**TOWN OF CARMEL
PLANNING BOARD**

**PLANNING BOARD AGENDA
NOVEMBER 24, 2020 – 7:00 P.M.**

RE: Stillwater Business Park
105 Stillwater Road
Town of Carmel
TM#s 75.17-1-53, 86.5-1-25, & 86.5-1-26

PROJECT: STILLWATER BUSINESS PARK			
STILLWATER ROAD, TOWN OF CARMEL, COUNTY OF PUTNAM, NEW YORK			
DRAWING: LAYOUT AND LANDSCAPE PLAN			
PROJECT NUMBER 18189.100	PROJECT MANAGER J.J.C.	DRAWING NO. SP-1	SHEET 2
DATE 6-26-20	DRAWN BY C.B.Z.	CHECKED BY A.D.T.	8
SCALE 1" = 40'

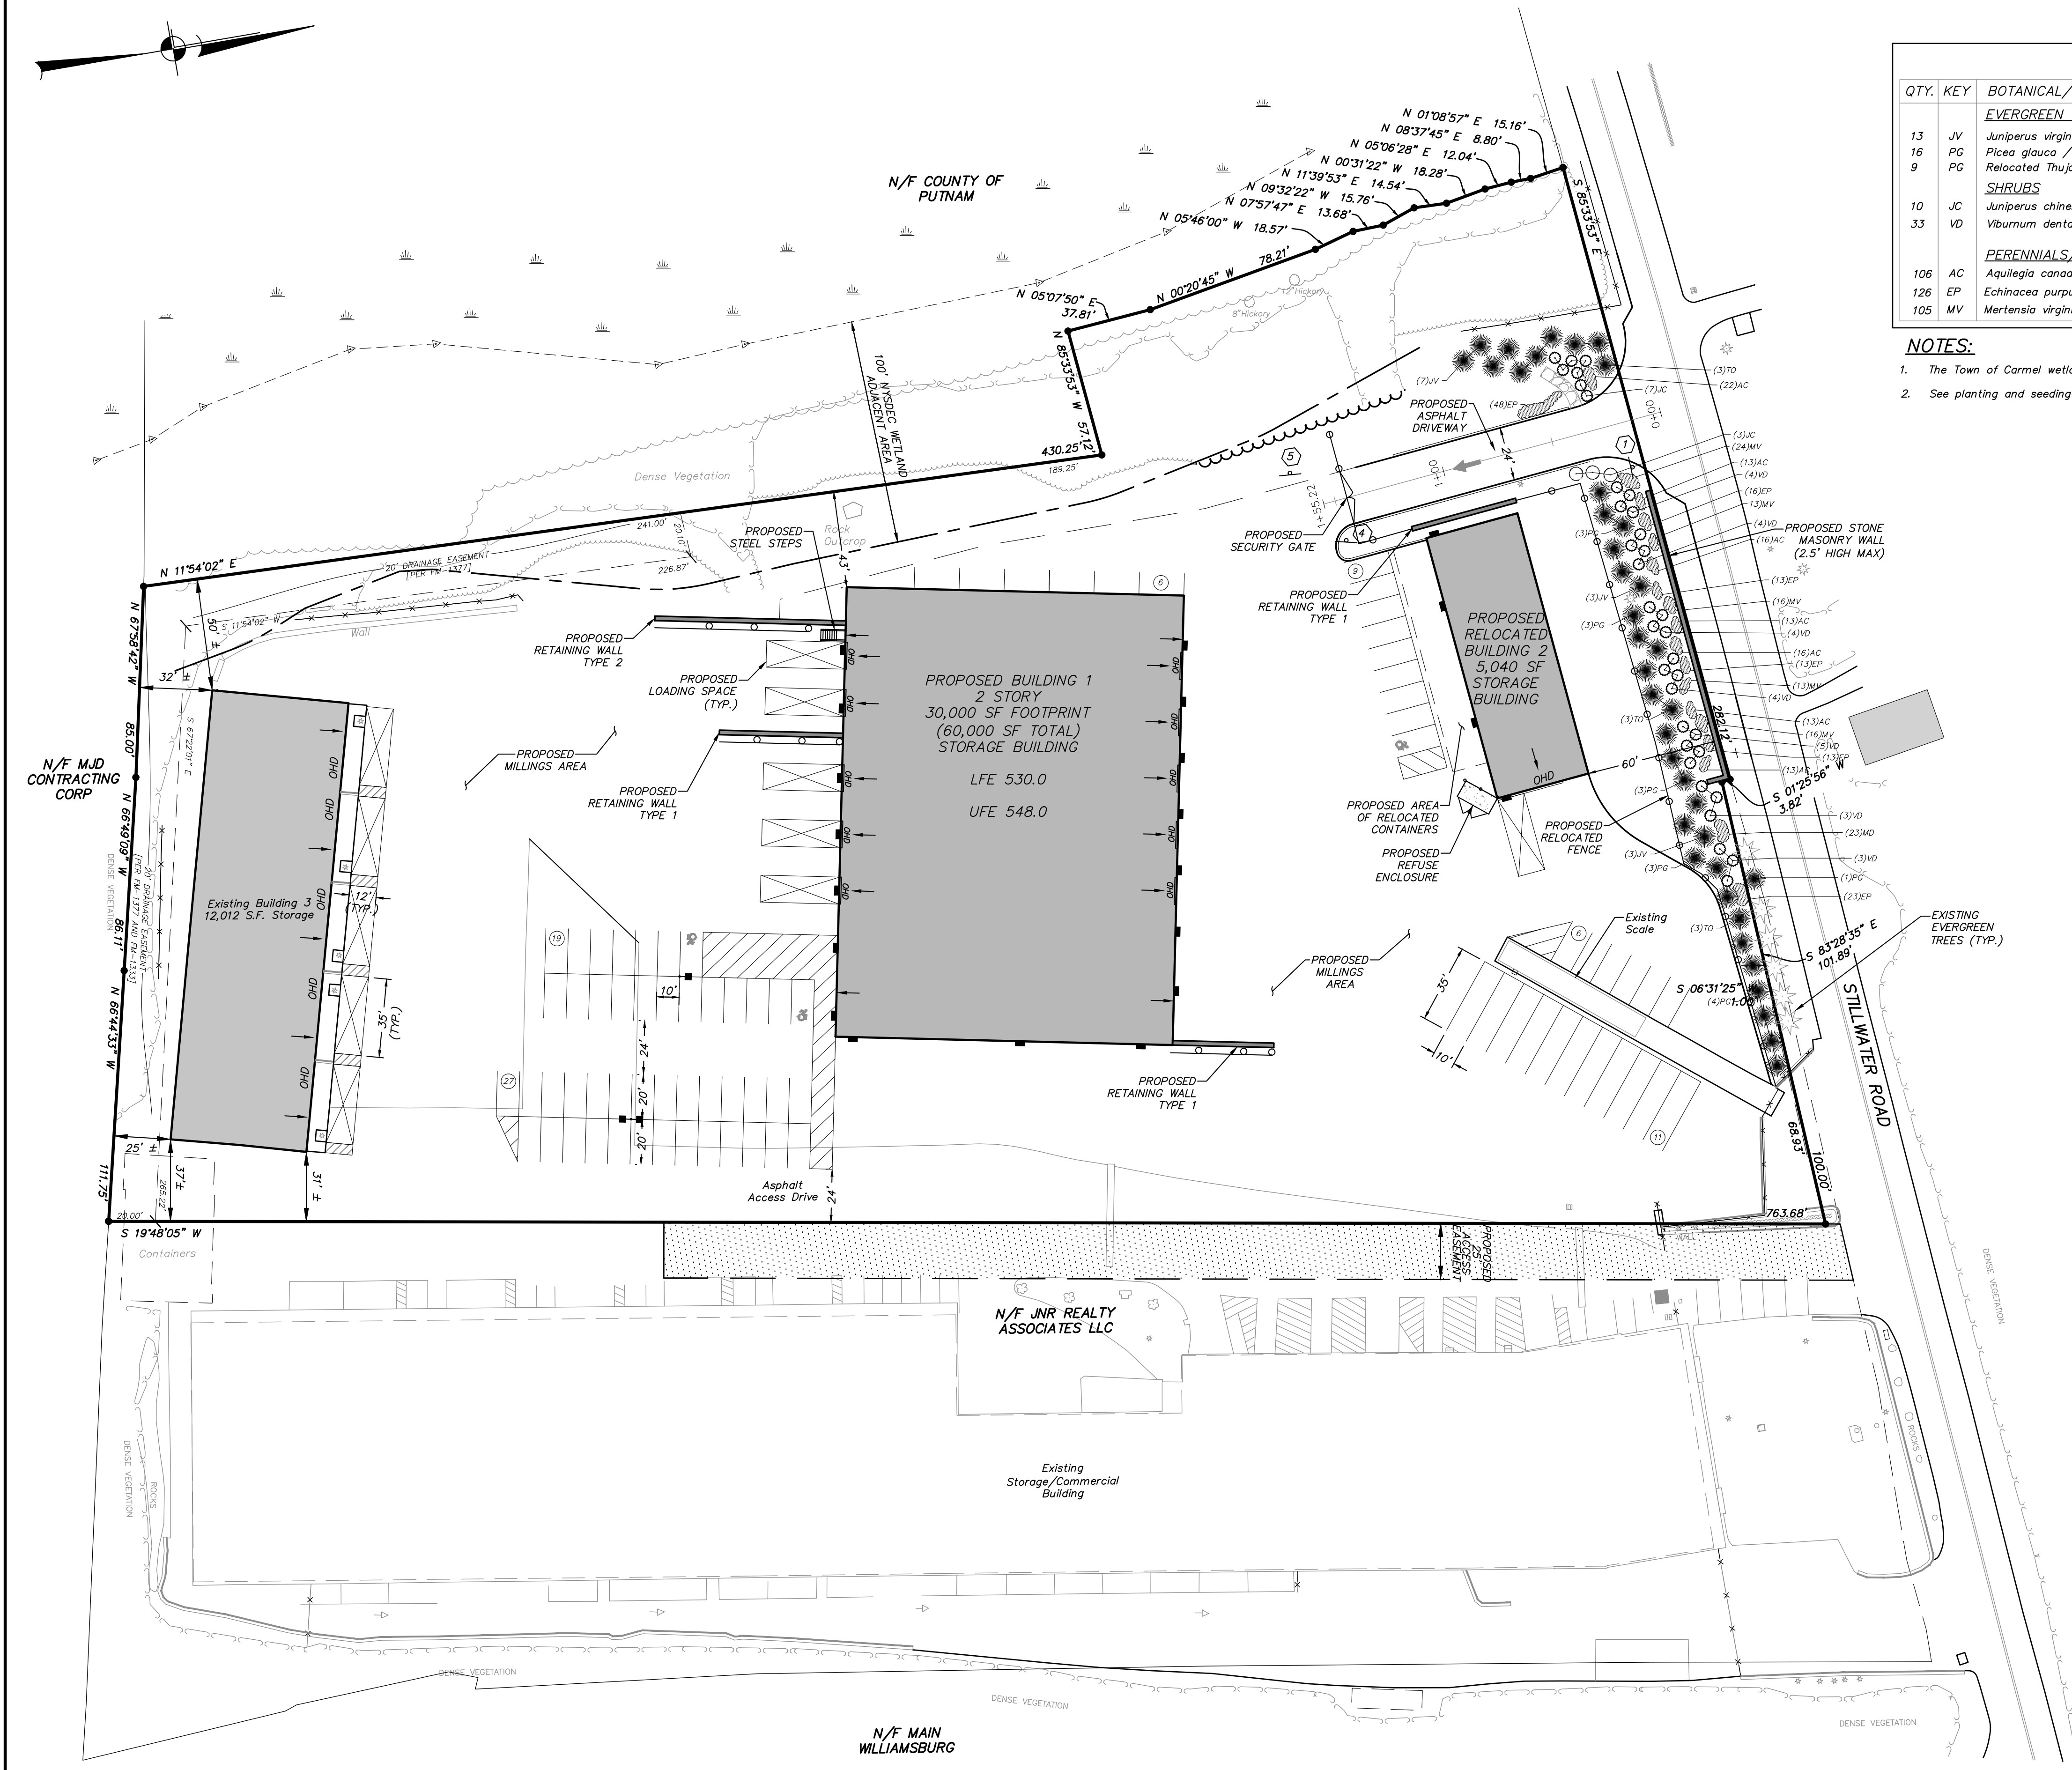
1. Layout and Landscape Plan SP-1
 - a. There is a note in the Planting Notes on sheet D-1 stating that all plantings shall be installed per §142 of Town of Carmel Code.

- b. A note has been added to sheet SP-1 stating that all plantings are to be verified by Town of Carmel Wetlands Inspector.
2. Grading and Utilities Plan

- NOTES:**
- The Town of Carmel wetland inspector to verify all plantings.
 - See planting and seeding notes on sheet D-1.

PROJECT NUMBER	18189.100	PROJECT MANAGER	J.J.C.	DRAWING NO.	SP-3	SHEET	4
DATE	6-26-20	DRAWN BY	C.B.Z.	CHECKED BY	A.D.T.		8
SCALE	1" = 40'

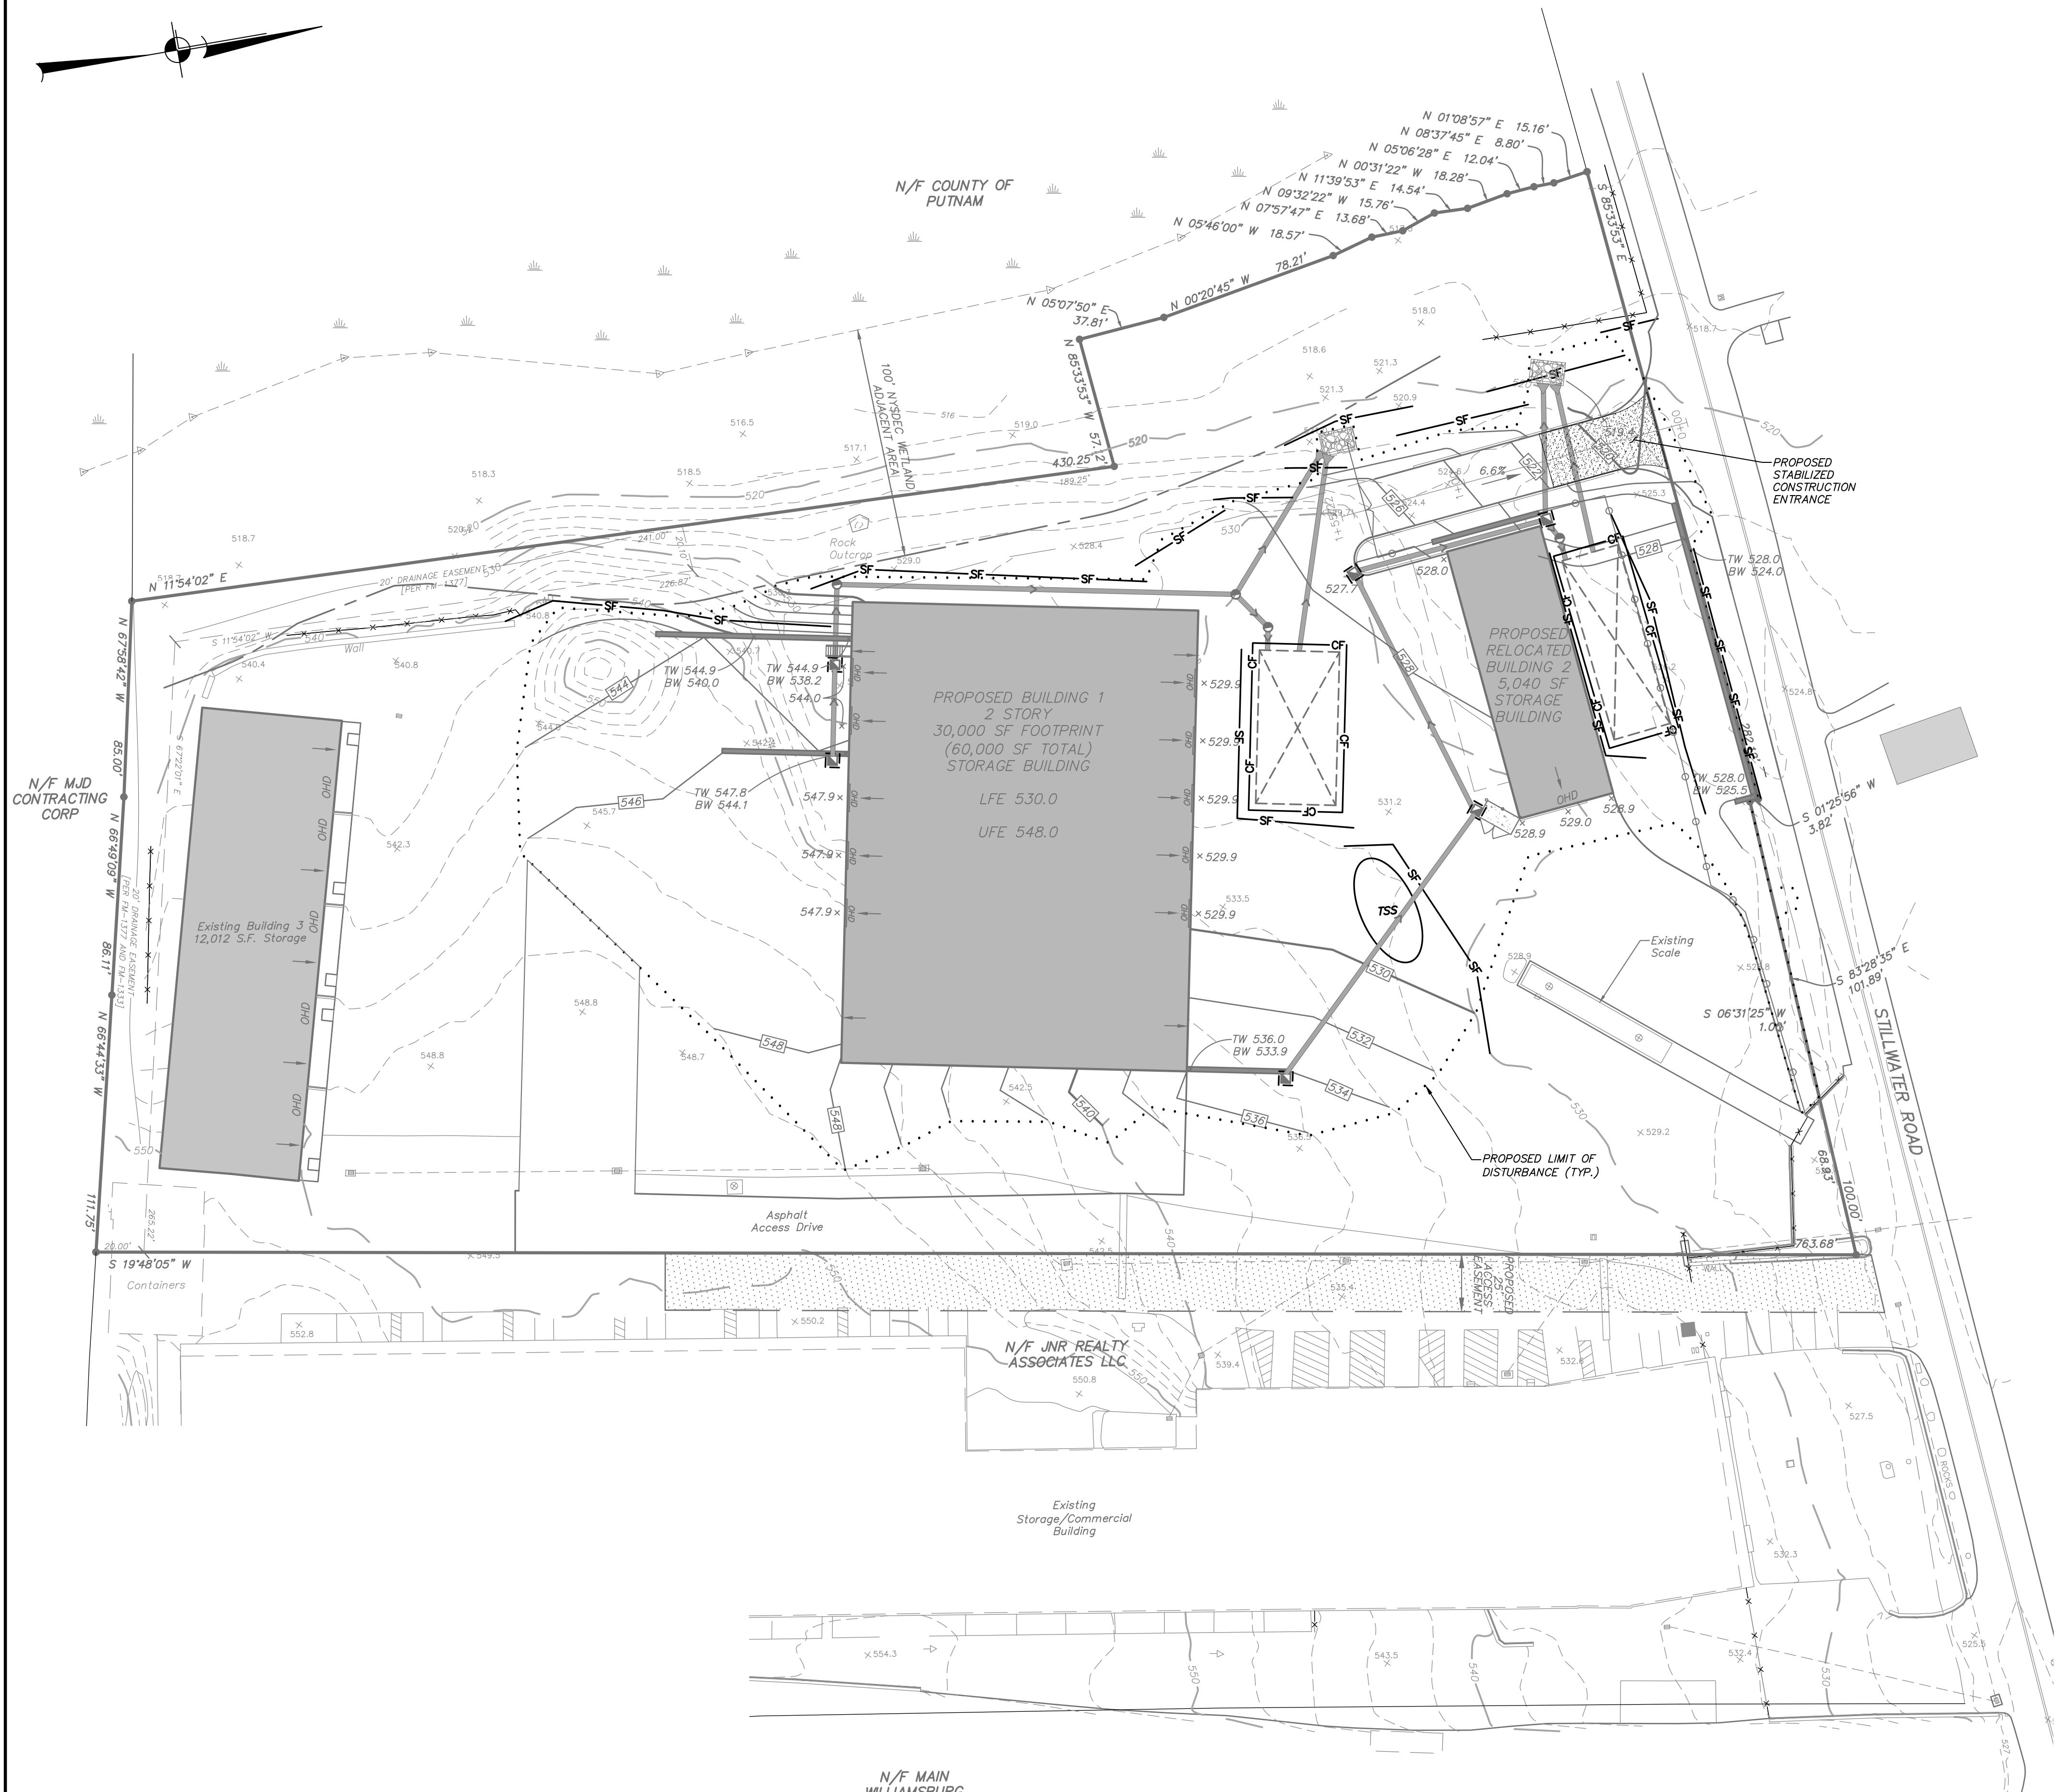
- b. Drainage profiles will be provided with a future submission.
3. Erosion and Sediment Control Sheet SP-3
 - a. A SWPPP has been provided, and dialogue is ongoing.

RETAINING WALL-TYPE 2 DETAIL
(N.T.S.)

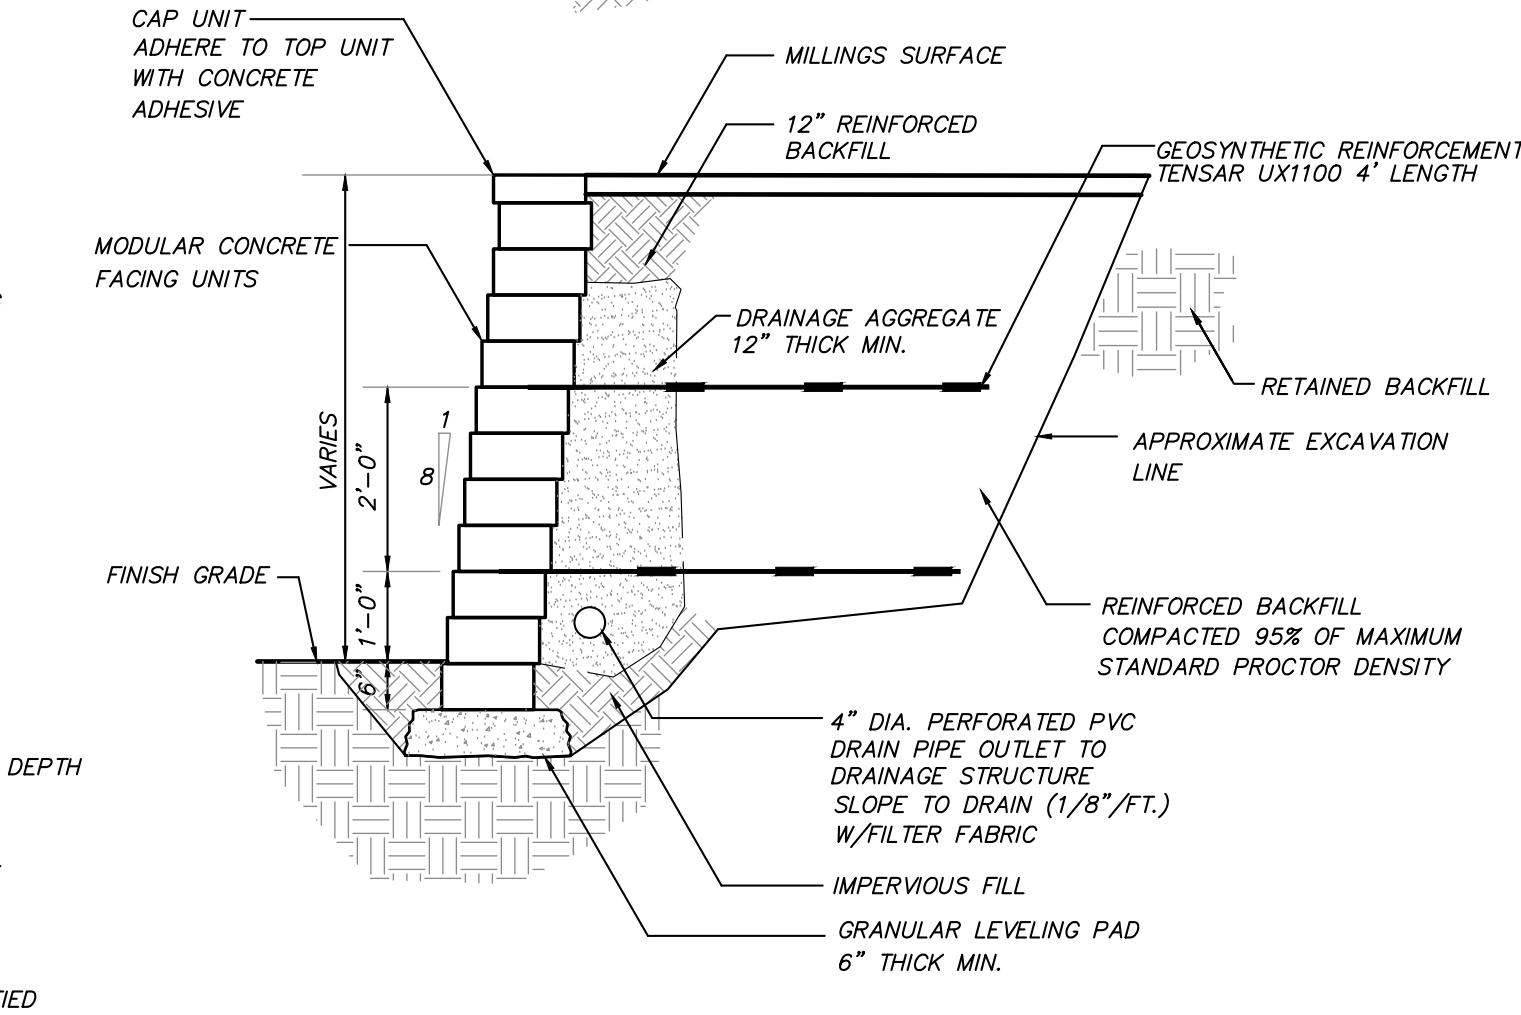
- a. The retaining walls on the site have been identified by type. It is noted in the detail for Proposed Retaining Wall- Type 2, that drawings sealed by a licensed engineer, must be provided for the structural design of the wall. These drawings will be provided with the application for building permit.

NOV. 16, 2020	
OCT. 29, 2020	
DATE	SEPT. 29, 2020
SCALE	1" = 20'
DRAWN	AC
JOB	15-G10
SHEET	S-3
CH	D-4875

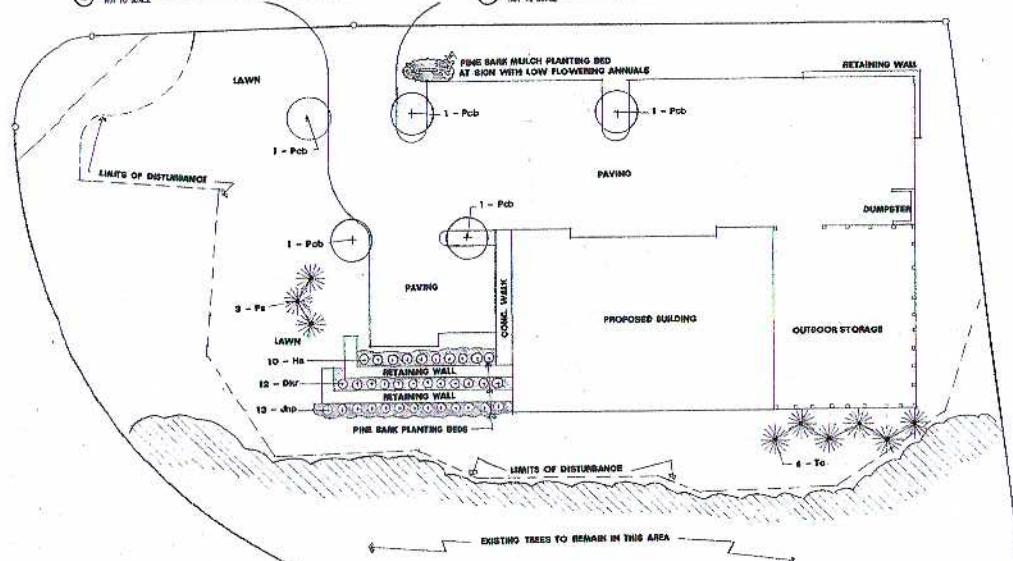
As a follow-up to our last Planning Board meeting and as directed by the Board, we have added additional landscaping in the form of evergreen trees to shield the fenced in storage area from Nicole Way on the southeast corner of the property.
